STAFF REPORT
COMMUNITY DEVELOPMENT DEPARTMENT

SUBJECT: H-2021-0007 – Seasons at
Meridian/Winco Wells Subdivision
H-2020-0118 – Volante Investments

LOCATION: 2600 & 2700 E. Overland Rd., in the SE
¼ of Section 17, Township 3N., Range
1E. (Parcels: S1117438626,
S1117438451)

A. Preliminary Plat (date: 02/4/2021) & Phasing Plan

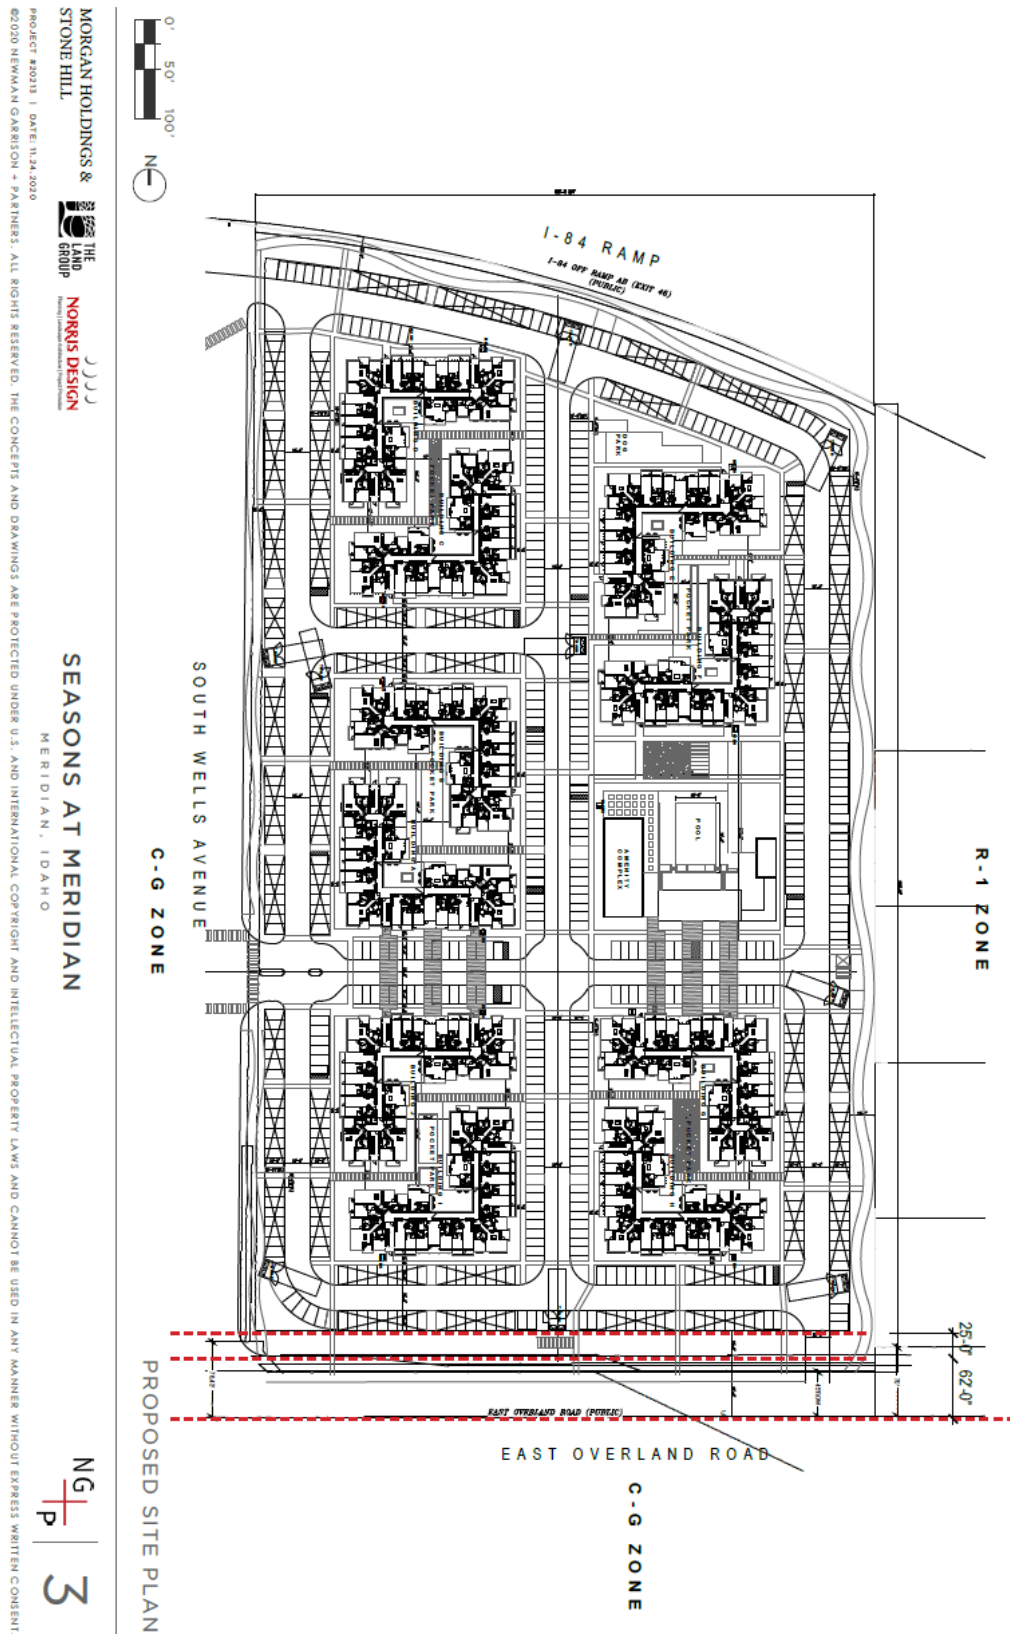
Required street buffer widths are as follows: 25-feet along E. Overland Rd., an arterial street; 10-feet along S. Wells Ave. and E. Cinema Dr., both local streets; and 35-feet along the I-84 off-ramp, an entryway corridor. Street buffer widths are proposed on the landscape plan in accord with these standards. **The plan is missing the street buffer along I-84 on the west parcel (Lot 2, Block 1); the plan should be revised to include this buffer.**

The number of trees proposed in buffers meets the minimum standard; however, a mix of trees and shrubs with lawn or other vegetative groundcover is required – shrubs should be added to the buffers in accord with UDC 11-3B-7C.3a. Street buffers are required to be placed in a common lot or on a permanent dedicated buffer, maintained by the property owner or business owners' association; the plat should be revised accordingly.

3. The final plat shall include the following revisions:
 - a. All street buffers are required to be placed in a common lot or on a permanent dedicated buffer, maintained by the property owner or business owners' association, as set forth in UDC 11-3B-7C.2b.
 - b. Depict the street buffer along E. Overland Rd. outside of the ultimate right-of-way for the widening of Overland to 7-lanes.
 - c. The extension of E. Cinema Dr. shall be included in the first phase of development.
4. The landscape plan included in Section VIII.B shall be revised as follows:
 - a. Landscaping is required to be provided adjacent to the pathway within the buffer along the I-84 off-ramp per the standards listed in UDC [11-3B-12C](#). *A mix of trees, shrubs, lawn and/or other vegetative ground cover with a minimum of one (1) tree per 100 linear feet of pathway is required.*
